Agency Name:	Champaign County
Project Name:	Champaign County Courtroom F Renovation
Project Location:	101 E. Main St. Urbana, IL 61801
Project Number:	ITB 2026-005
To:	Bidders
From:	Mitch Avitt / Bailey Edward Lucas McGill / AEI
Issue Date:	09/14/2026

This addendum forms a part of the Contract Documents and modifies the original Bidding Documents dated 0821/2026 and any subsequent addenda. Acknowledge receipt of this Addendum in the space provided on the Bid Form. Failure to do so may subject the Bidder to disqualification.

ADDENDUM NO. 1

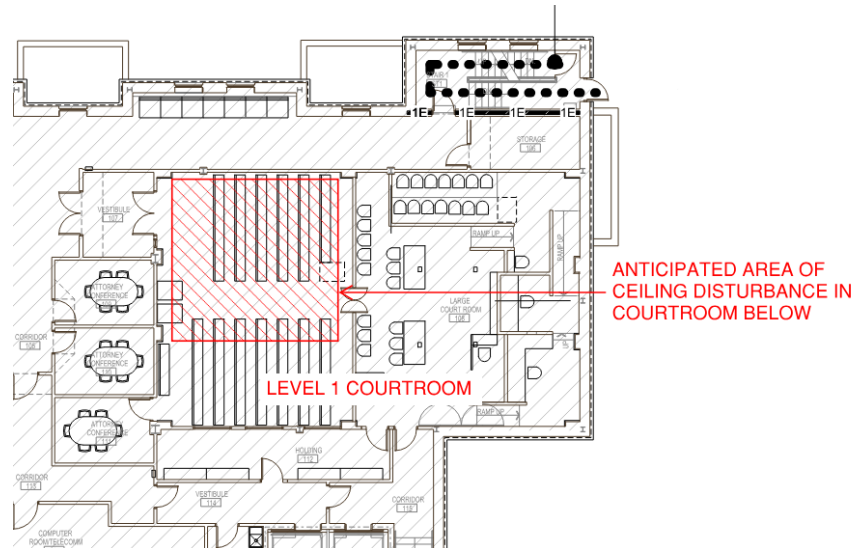
- 1) The pre-bid meeting included a potential staging area for materials, etc. (labeled B below). During the site visit another area was identified (labeled A below).
 - a. Area A is likely to be the available staging area.
 - b. Final location to be coordinated with Owner.
 - c. Area to be fenced and screened.
 - d. If GC chooses to stage outside on grass or pavement, the concrete and lawn to be restored to Owner's satisfaction
 - e. Elevator access adjacent to location A
